Section 4.56 Application

149–163 Milton Street, Ashbury

This modification report (**report**) has been prepared by Urbis Ltd on behalf of Ashbury Projects Pty Ltd (the Applicant) in support of a section 4.56 application to modify DA-826/2020 pertaining to land at 149-163 Milton Street, Ashbury (the site).

Figure 3 Approved and Proposed Basement Plan

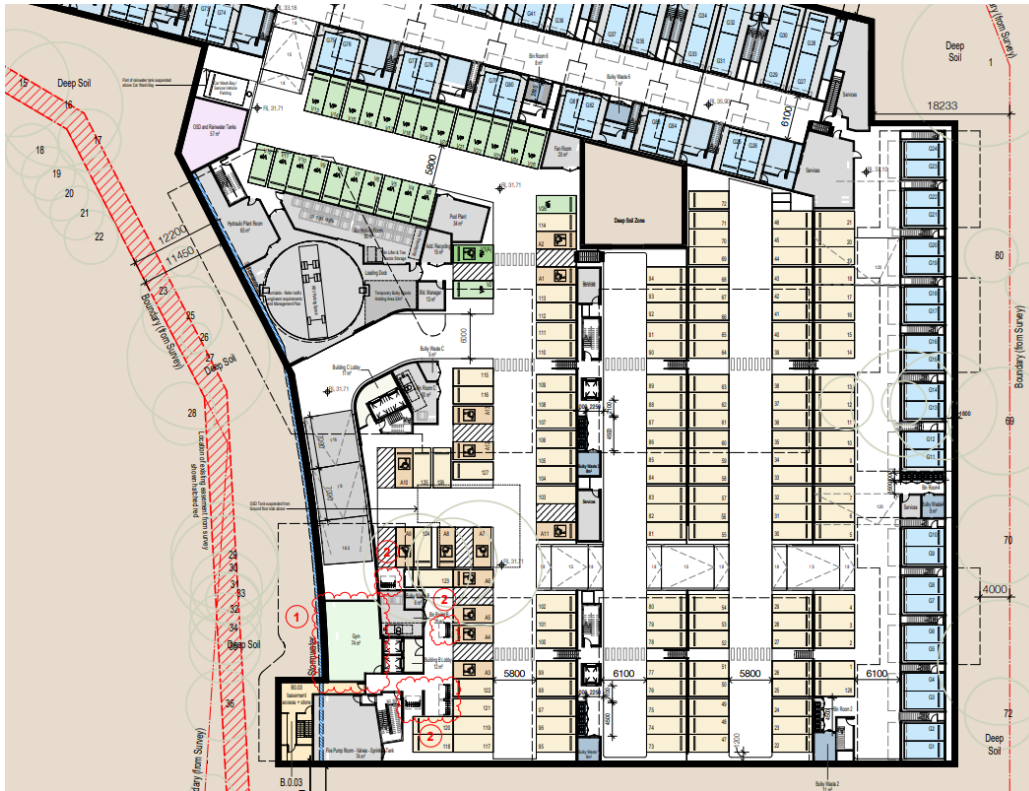
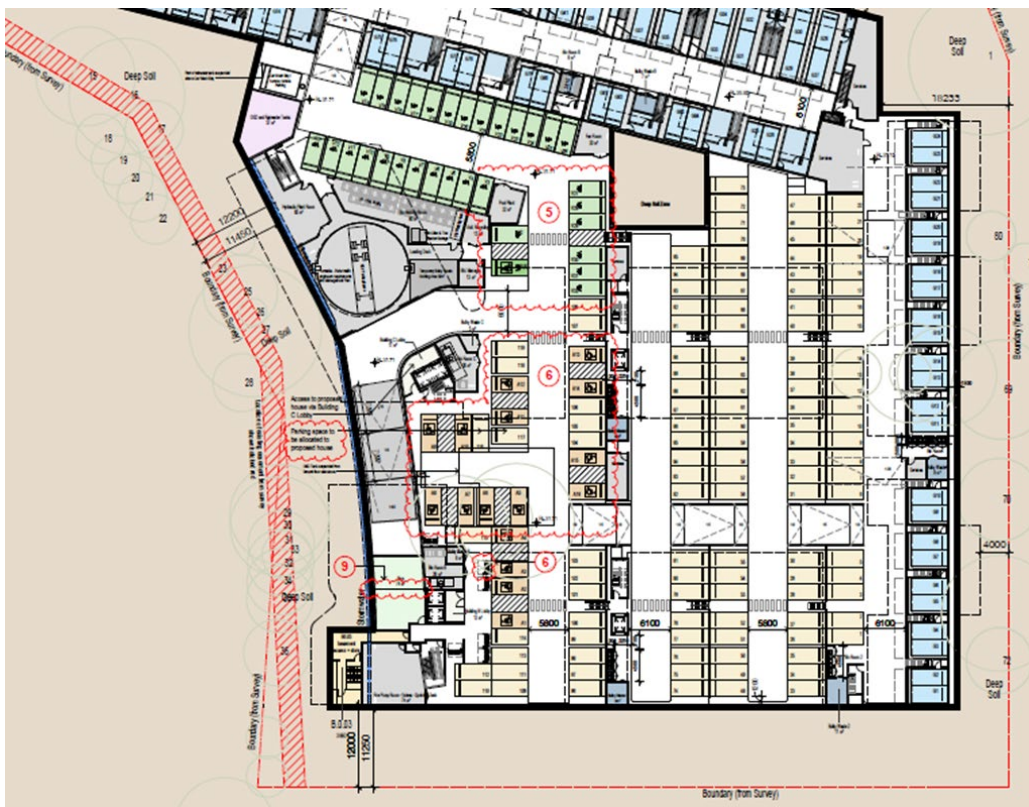
- Conversion of 10 resident parking spaces to 5 visitor spaces and 4 accessible resident spaces.
 - Addition of one visitor car parking space.
- Provision of additional bicycle parking at the basement and ground levels, including adjacent to parking space A3 in the basement and between Buildings C & E at ground level. These modifications will result in an increase in bicycle parking from 39 spaces to 48 spaces.

Picture 2 Proposed Basement Plan showing changes to carparking layout and allocation

Figure 4 Approved and Proposed Ground Floor Plan
s4.56 Report - 149-163 Milton Street, Ashbury

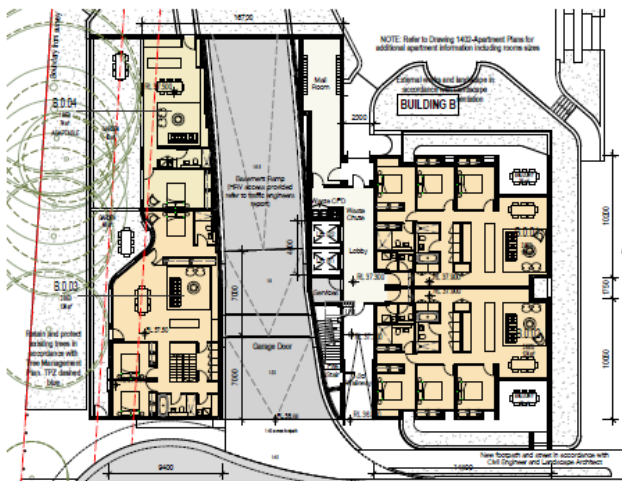
- Minor external façade changes to facilitate an increase in window size for studio apartments created on the western façade of Building B, as well as the addition of a window to the ground floor mail room in Building B.

Picture 6 Proposed Building B Floor Plans

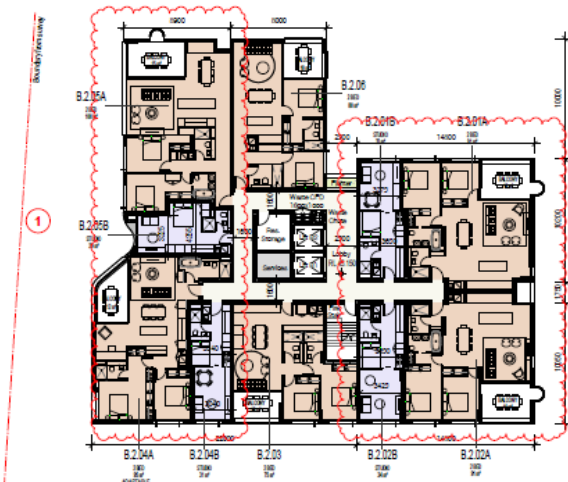
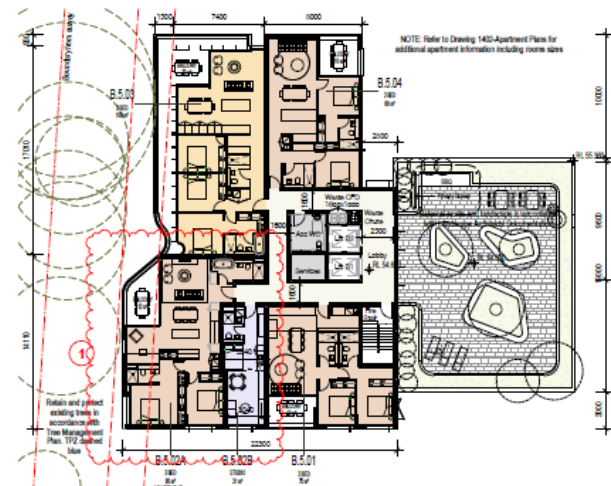
- Internal amendments to the layout of Buildings B and C, specifically the conversion of larger two- and three-bedroom units to studio, one-bedroom and two-bedroom units. This will result in an increase in the total dwellings on the site from 131 dwellings to 158 dwellings.

Figure 6 Approved and Proposed Building C Floor Plans

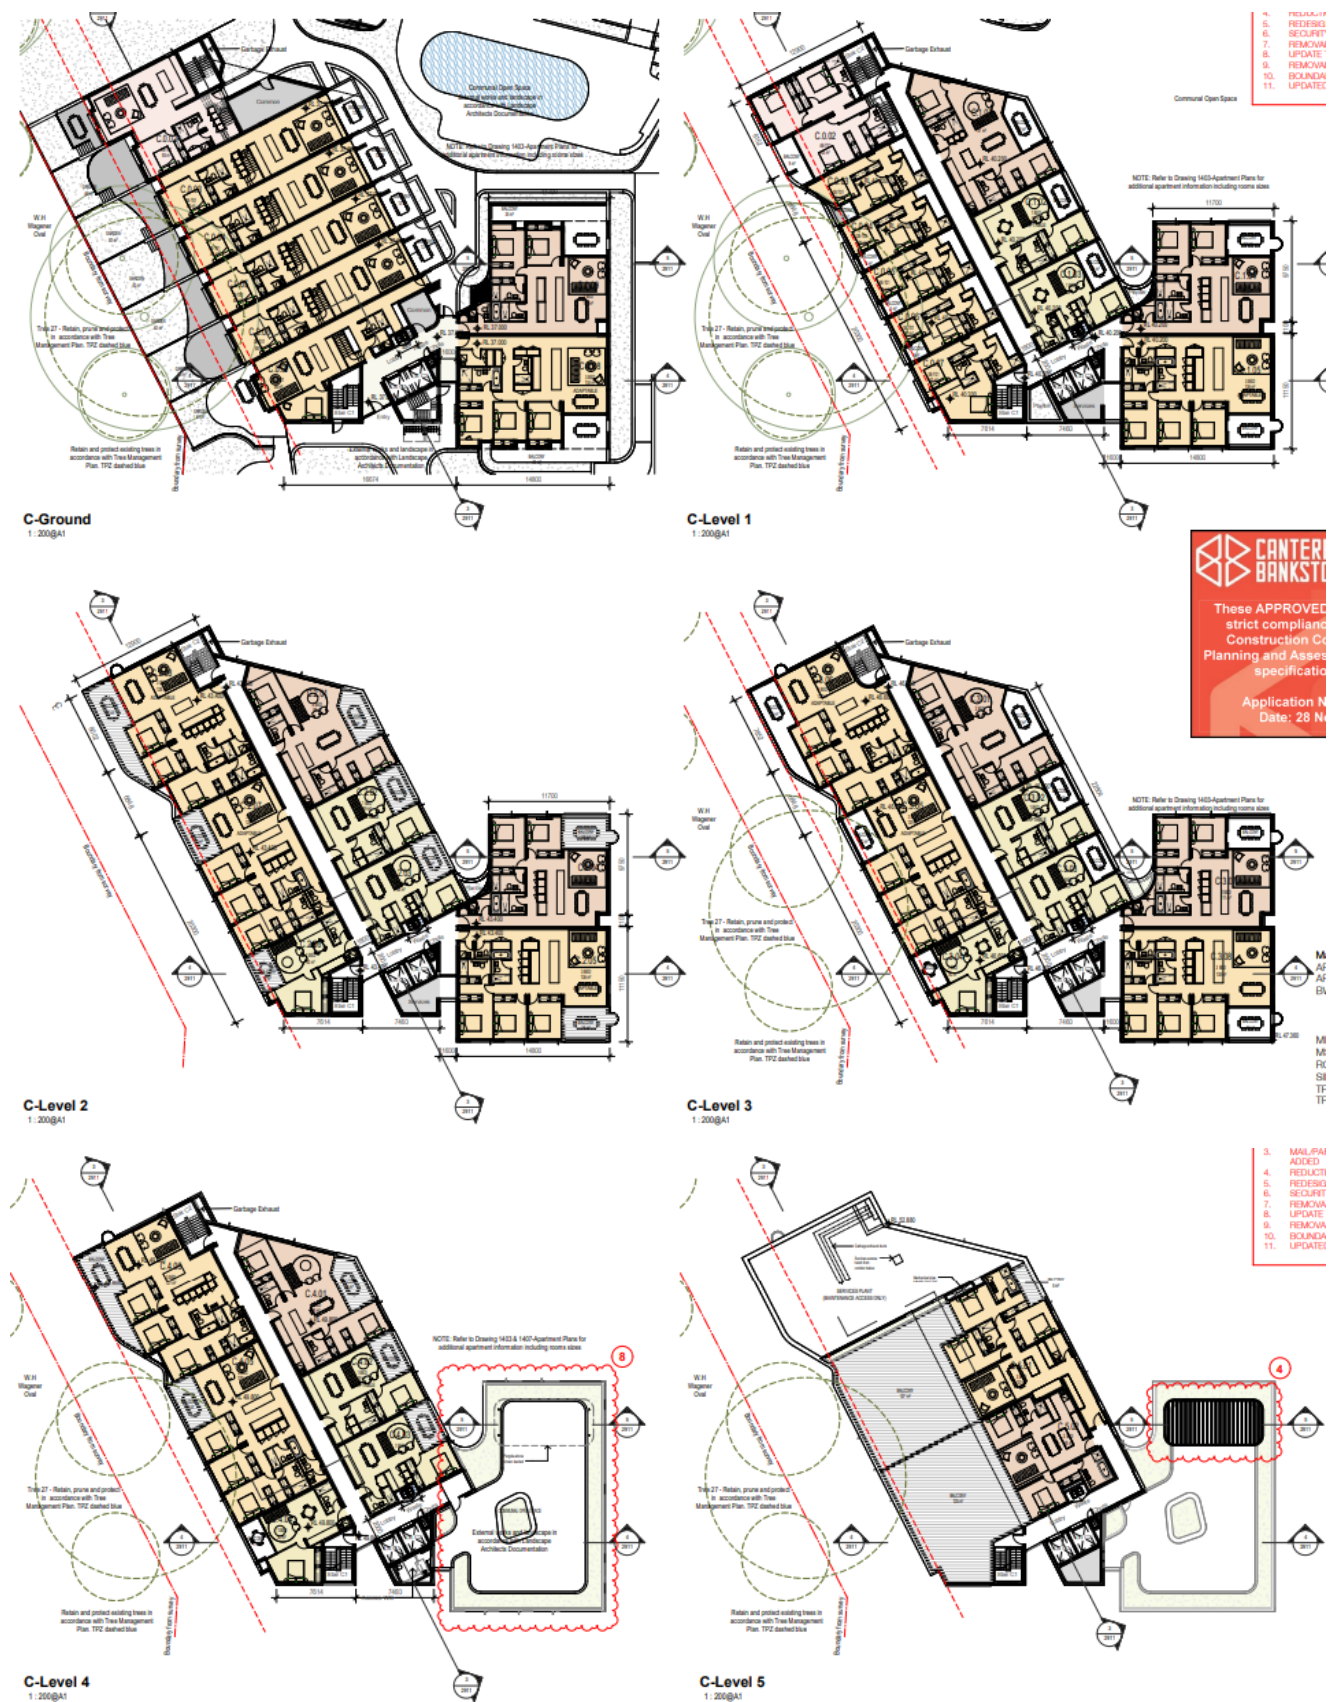
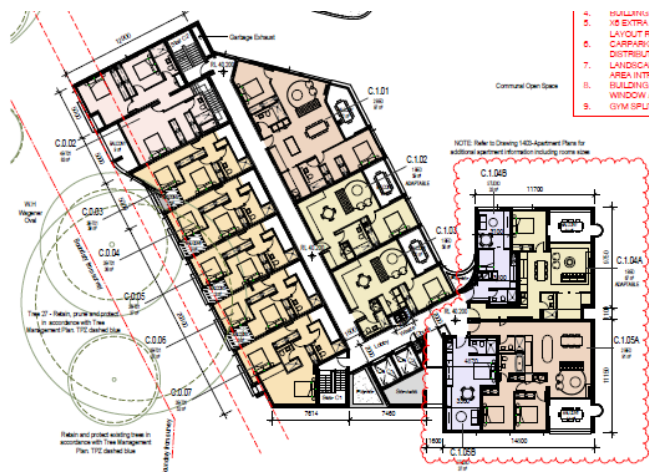
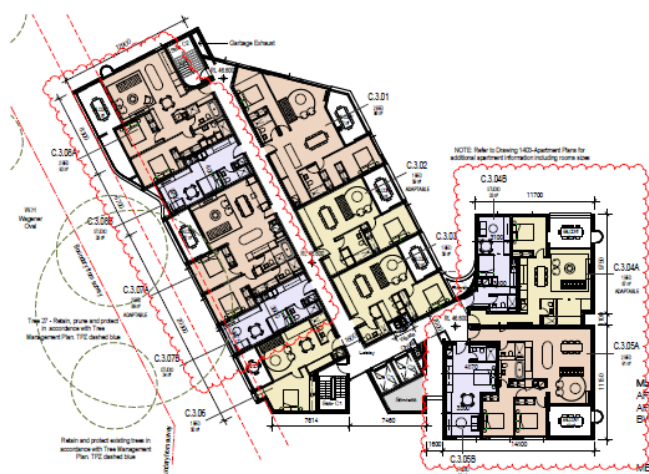
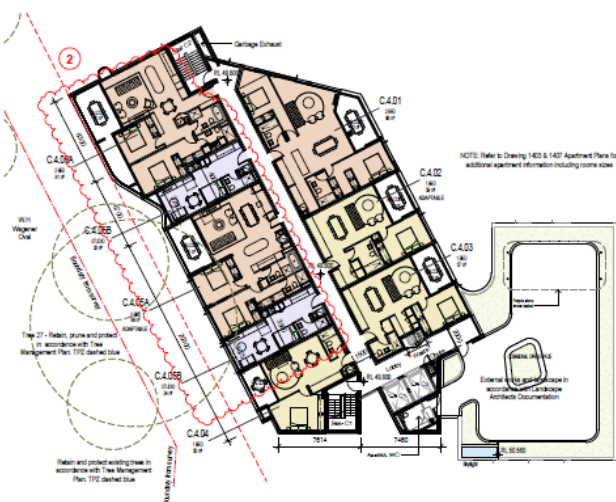
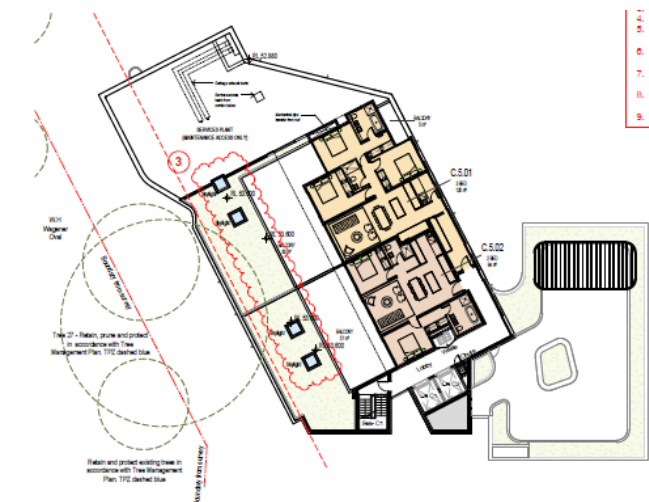
- Introduction of rooftop skylights to Building C.
- Provision of a staircase on the western end of the northern communal open space adjacent to Building D2 to provide access to the communal open space and pool area from the west.
